DOCUMENT CHANGE REQUEST

DCR number 506	Changes required for: General	Originator: S Jeffery - ESCC
Date: 2009/04/29	Date sent: 2009/04/29	Organisation: ESA/ESTEC
Status: IMPLEMENTED

Title:	Matched Dual Transistors NPN, based on types 2N2919/2N2920 and 2N2920A		
Number:	5207/002	Issue:	2

ESCC Detail Specification No. 5207/002

1.5 MAXIMUM RATINGS

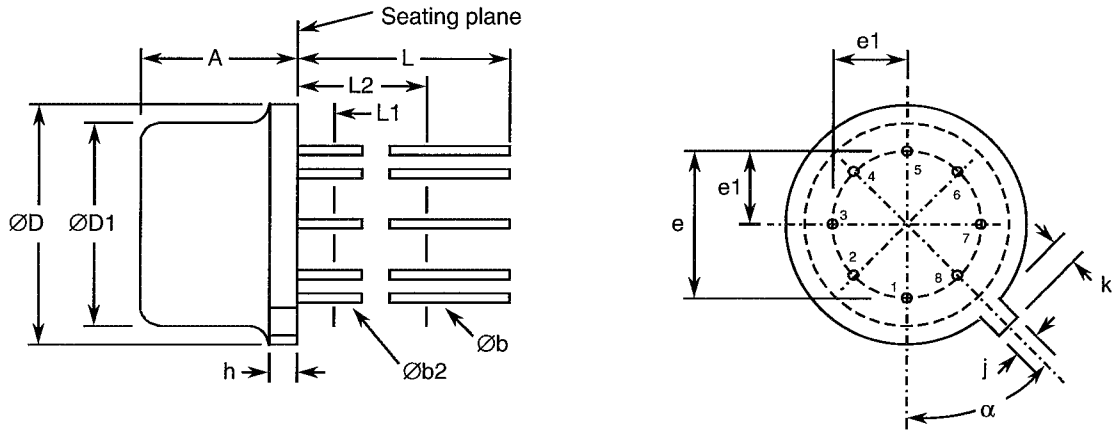
1. ~~For T_{amb} or $T_{case} > +25^oC$, derate linearly to 0W at $+200^oC$.~~ Thermal Resistance, Junction-to-Case
2. ~~When mounted on a 15 x 15 x 0.6mm ceramic substrate.~~
2. ~~3.~~ For Variants with tin-lead plating or hot solder dip lead finish all testing performed at $T_{amb} > +125^oC$

only applies to TO-77 packaged Variants.

shall be carried out in a 100% inert atmosphere.

Attachments:
5207002_Issue_3_-_Draft_A.pdf, null
Modifications:
Page 6: original Note 3 to Maximum Ratings, add ", and any handling,"between "testing" and "performed".
Approval signature:
